Memorandum

To: Planning Commission
From: Niall Connolly, Director of Community Development
Date: August 14th, 2026
Re: Design Development Review for Parking Lot Expansion at 50 Zion Park Blvd

This is a retrospective Design Development Review Application for an expansion to the parking lot at 50 Zion Park Blvd. The expansion involves 15 new parking spaces, as well a restroom and a commercial use as required by the Code.

Figure 1. Location restroom and trash receptacles

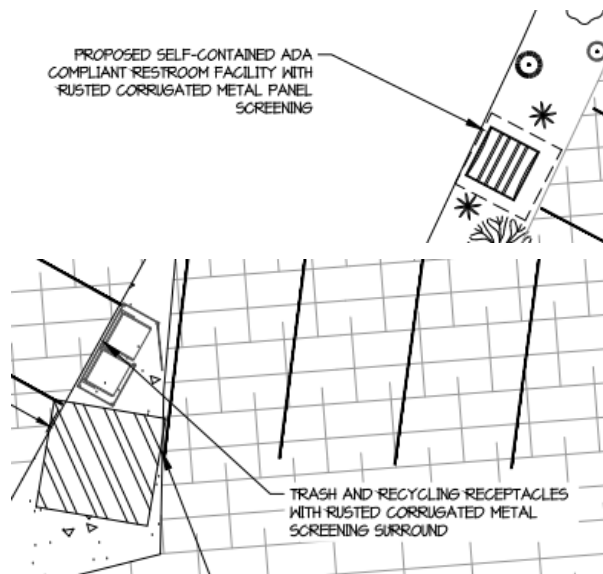
The plan shows the location of the proposed restrooms and trash receptacles (see screenshots below). The plan states that these areas will be screened with rusted corrugated metal panels. A photo showing a sample of the proposed material is included.

Figure 3. Location of proposed coffee truck

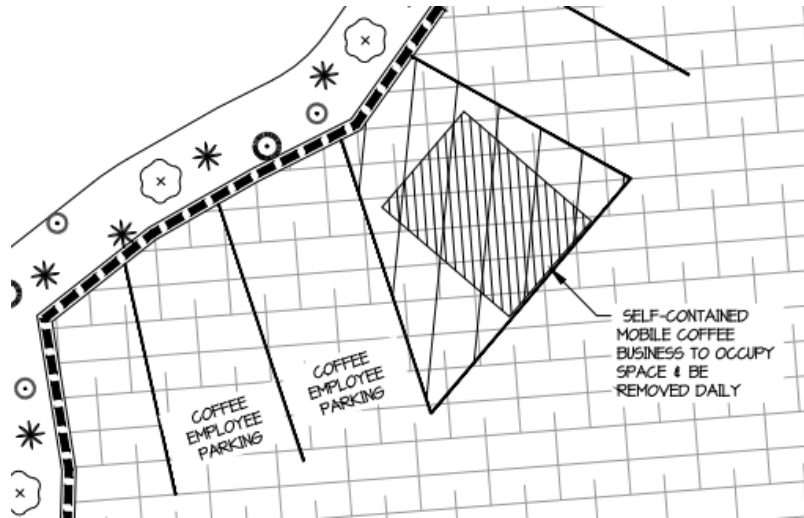
The location of the proposed mobile business is identified on the plan, along with two employee parking spaces. It is setback approximately 48 ft from the front property line. The minimum front setback in the Village Commercial zone is 30 ft for structures up to 18 ft in height, and 50 ft for structures exceeding 18 ft in height. Although dimensions of the mobile business have not been provided, it is most likely that a mobile coffee truck would not exceed 18 ft in height. Therefore, the proposed location of the mobile business complies with minimum setback standards.

A mobile business would be subject to the standards set out in section 10-22-11 of the Town Code. Significantly, the mobile business would only be allowed to remain on the property for three hours each day. The Commission should make a determination on whether or not this fulfills the commercial use requirement envisaged by the Code, and the practicality of enforcing this requirement.

Figure 4. Proposed parallel parking spaces, in place of the acute angled spaces

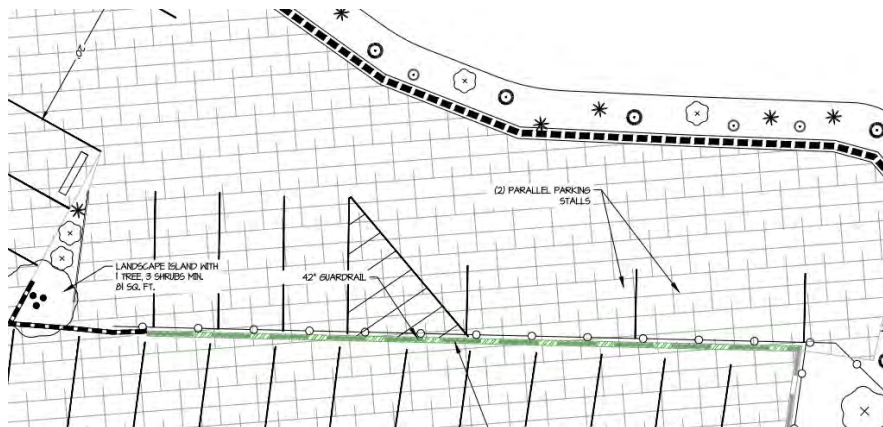
The layout has been revised to create two parallel parking spaces in the place of acute angled spaces of the previous layout.

Figure 6. Approved grading plan

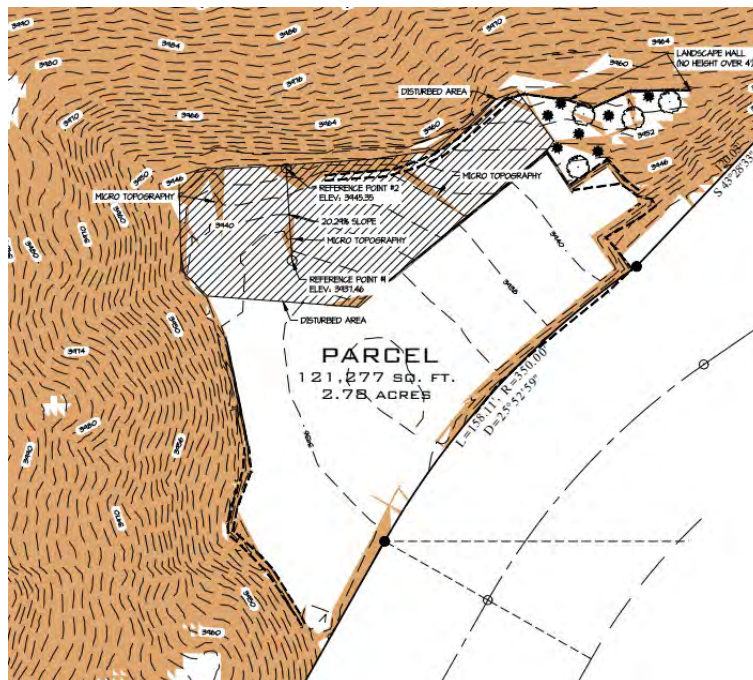
In his letter, Mr. Wilson argues that if a geotechnical report was necessary, it should have been required at the time the grading permit was being processed. It was at that time that the grading at the foot of the hillside was being reviewed. The grading permit was approved by staff, and the DCD did not determine at that time that a geotechnical report was required. In Mr. Wilson's view, the purpose of this DDR application is solely to review the various improvements (i.e. restrooms, commercial use, landscaping etc) that were triggered by creating these extra parking spaces. He believes that an assessment of any potential geologic hazards is not relevant to this application. The Commission should review this request and determine whether or not to require the geotechnical report.

Figure 6, above, shows the grading that was approved. The black and white hatched area is the expanded parking lot area, and the brown shaded area represents slopes of 30% or greater. The

SITE PLAN
FOR
SPRINGDALE PARKING LOT
SPRINGDALE
UTAH

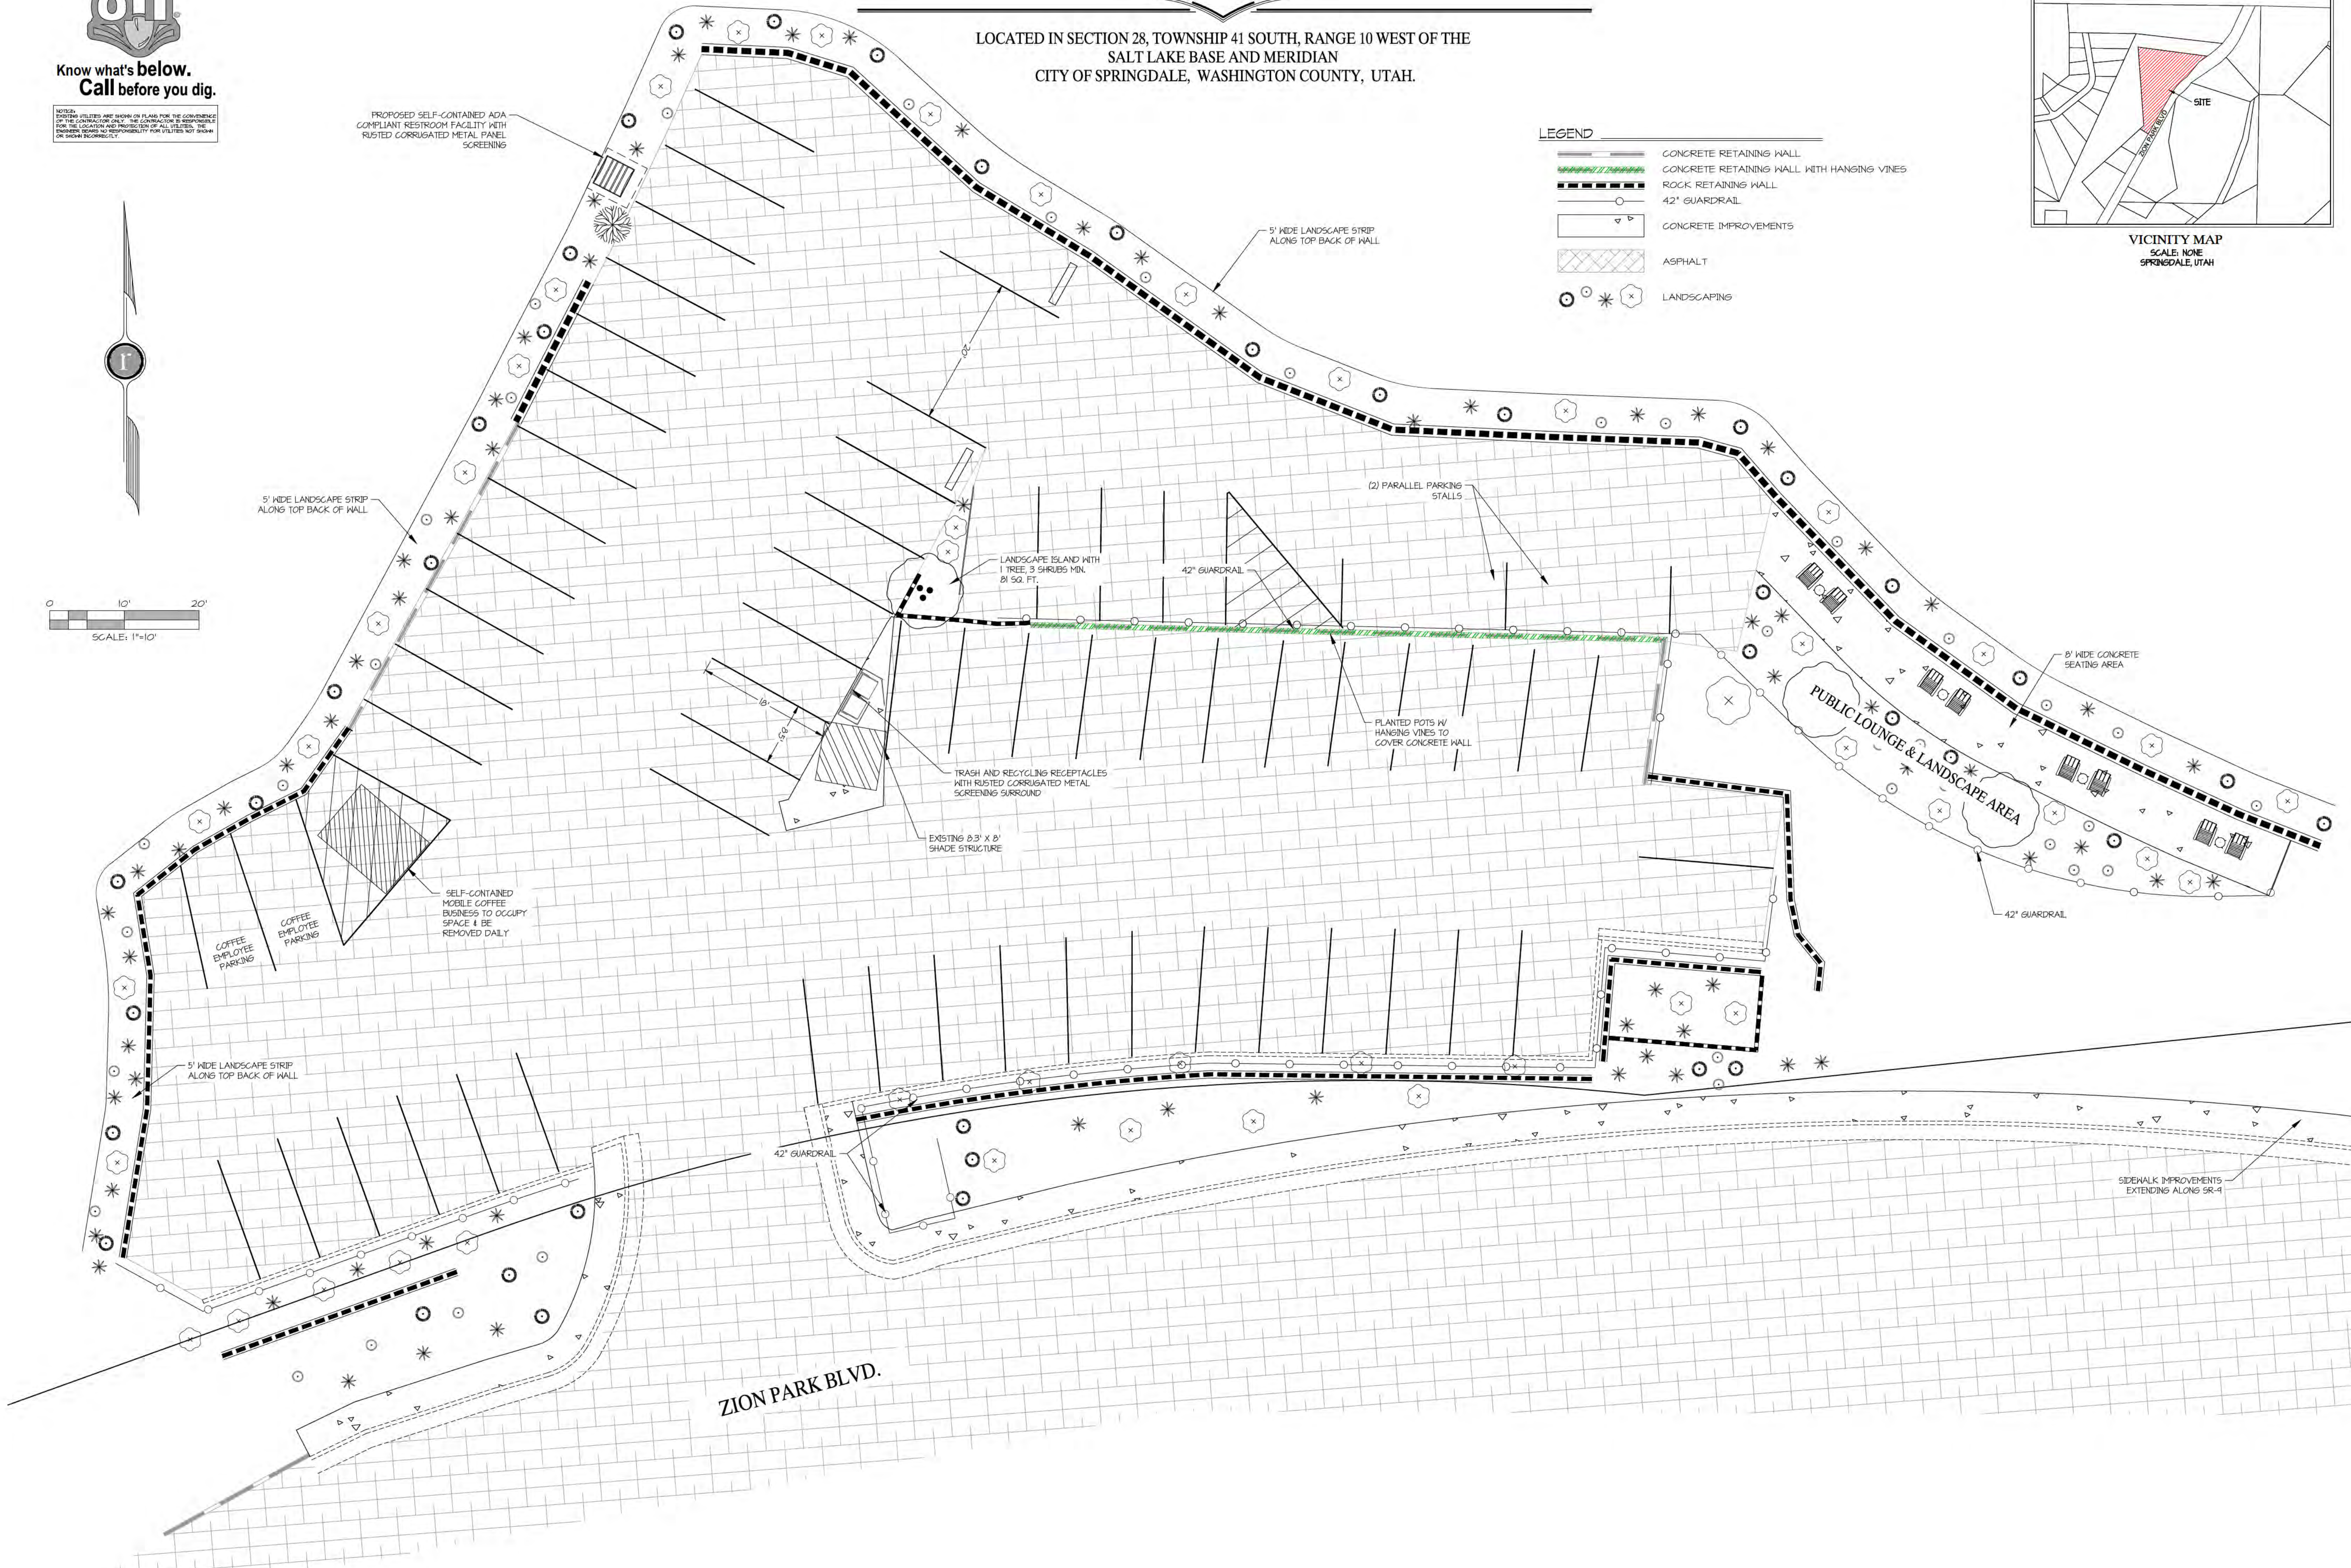
A landscaped area is shown at both ends of the new aisle of parking spaces. Both of these landscaped areas exceed 80 sq ft. The new head to head spaces do not have a 4 ft wide planter between them. The applicant has suggested that this landscape buffer could be provided vertically, by providing hanging landscape.
